**Transition to 10 CFR 50.48(c) - NFPA 805
Performance-Based Standard for Fire Protection for
Light Water Reactor Electric Generating Plants, 2001
Edition**

Transition Report

Figure 1-1 NFA 805 Transition – Implementation Requirements/Guidance

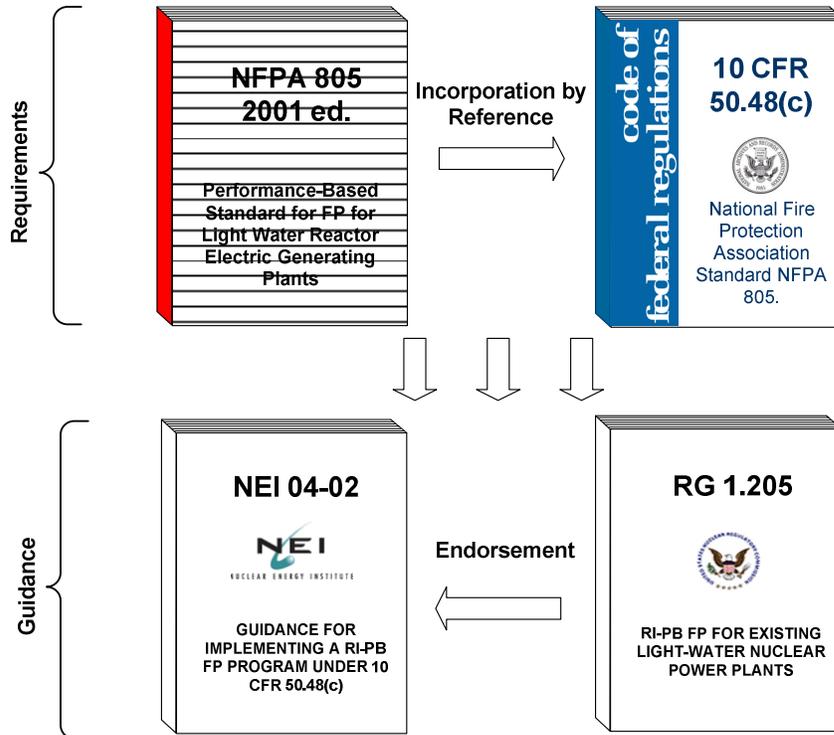
Comment [M4]: Will a licensee submit this figure in the LAR? Recommend deleting.

Figure 3-1 NFA 805 Process [NEI 04-02 Figure 3-1 based on Figure 2-2 of NFA 805]²

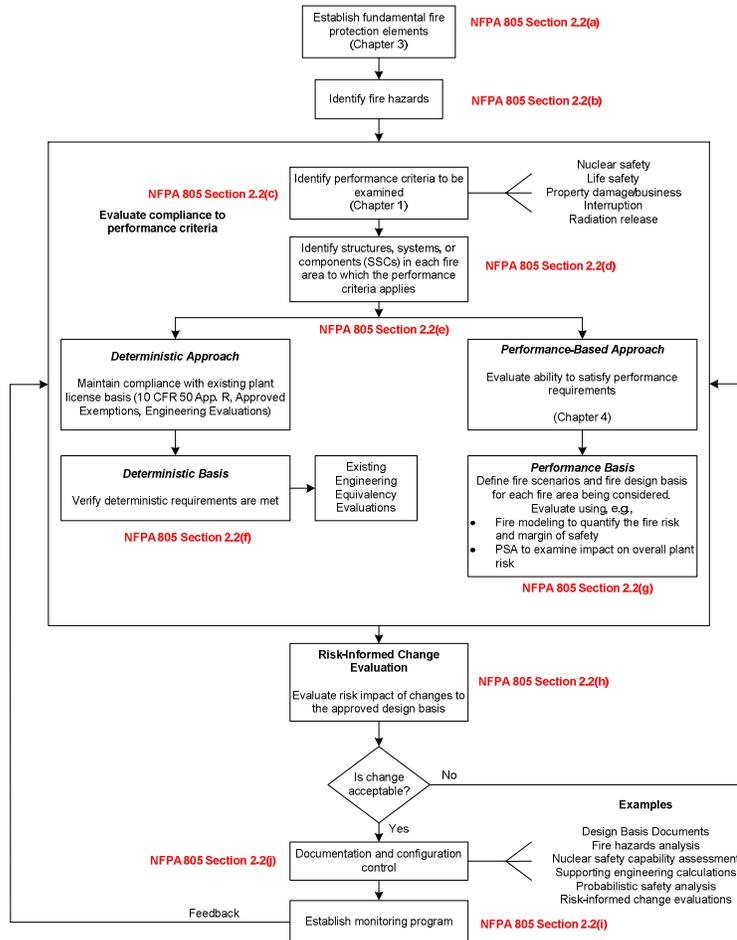
Comment [M6]: Will this go into a plant's LAR? What is the value added?

Figure 4-4 Interpretation of the Effect of Closure of FAQ 06-008 on the Scope of EEEEs to be Submitted to the NRC for Approval

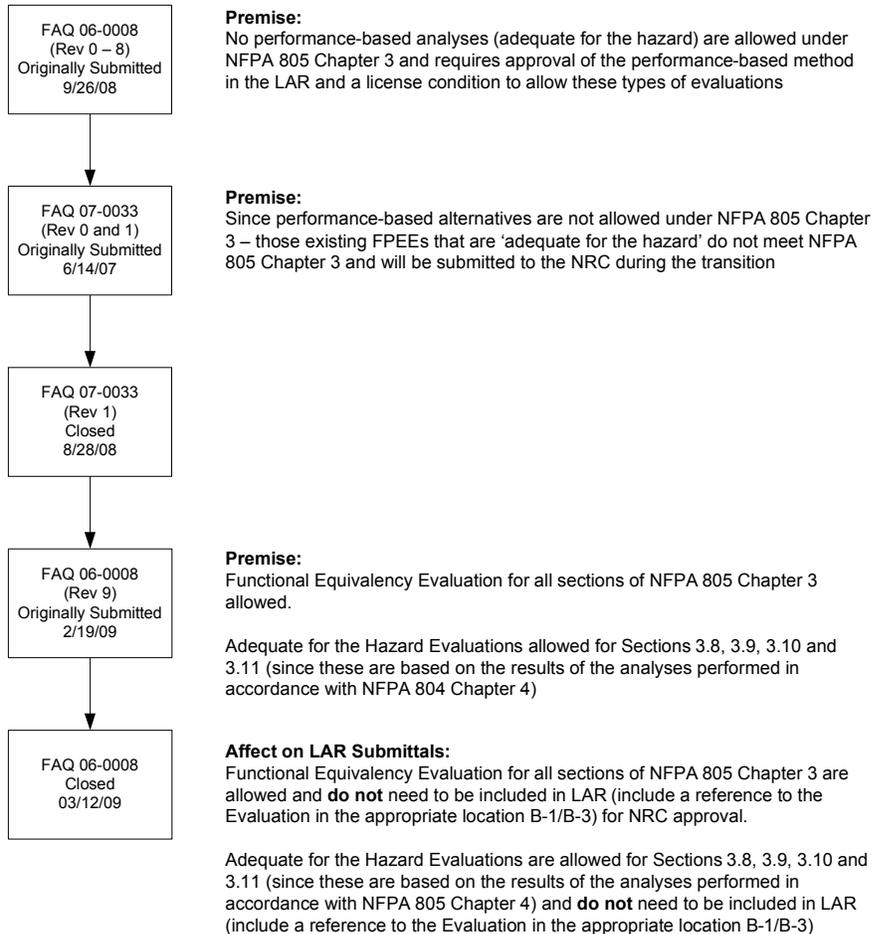
Comment [eak18]: NOTE TO LAR DEVELOPER:

NEI 04-02 revision 3 will clarify this. Until the next revision of NEI 04-02, this information should be provided for clarity

Figure G-1 General Process to Transition Operator Manual Actions (Ref. NEI 04-02)

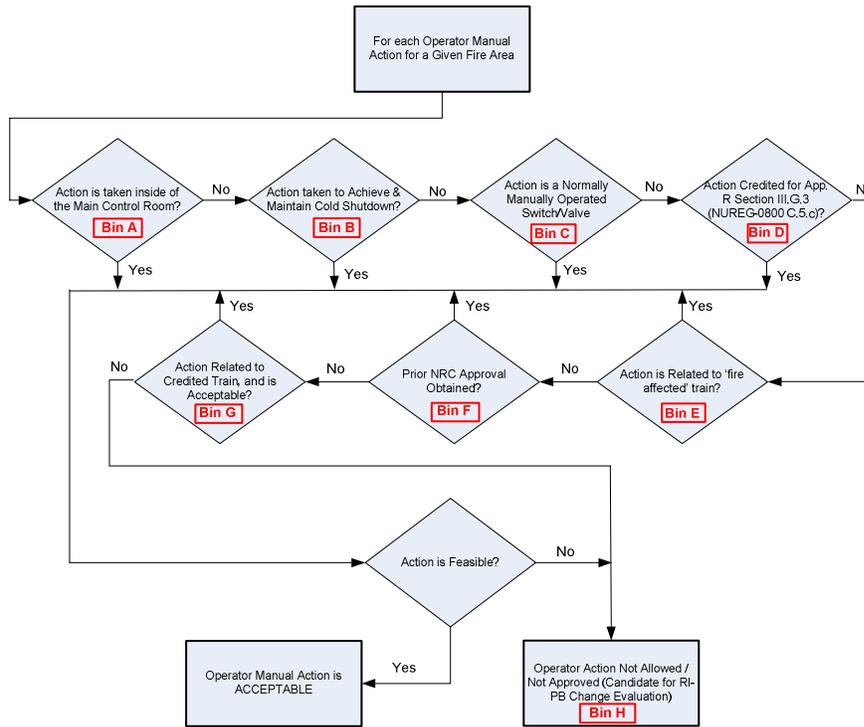
Comment [M25]: Does this imply that this step is applied only during the implementation period, or does it provide guidance for licensees who intend to establish permanent compensatory measures? Note, the NRC expects that a NFPA 805 licensing basis would not need to rely on permanent compensatory measures.

Comment [M26]: NRC commented on this flow chart in previous public meetings. It is not consistent with RG 1.205, Revision 1. Recommend basing the establishment of recovery actions on a different process.
